Date Issued :	July 26, 2022	PCN Number :	512325
Reason for Change :	Packaging Method/Quantity Changing		
Description of Change :	The purpose of this notice is to inform you that we will change the packaging accessories from foam paper to EPE foam, the carton size will be reduced, and Du and MLQ will remain unchanged. As part of this change, no change will be made to the product.		
Reason for Short Notice :	Special Request		
Assessment of Change :	Drop Test		
Planned Implementation Date :	January 01, 2023		
Sample Availability Date:	September 12, 2022		
Internal Molex Qualification Date :	September 10, 2022		
Last date to request Samples by Customer :	October 30, 2022

■ Impacted Products Pictures

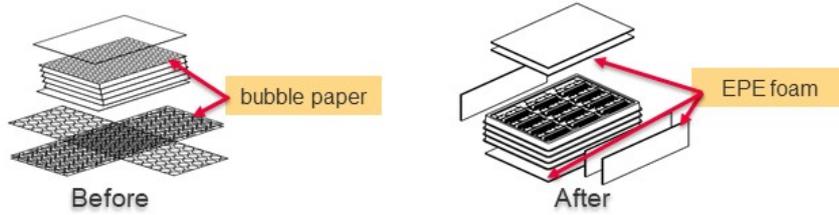
Change Packing accessories from bubble paper to EPE foam.

- Product Impact: no impact to fit, form or function, Tray /Packing Qty. are kept.
- Part Number Impact: see attached impacted parts list.
- Qualify method: Packing test PPAP level 4
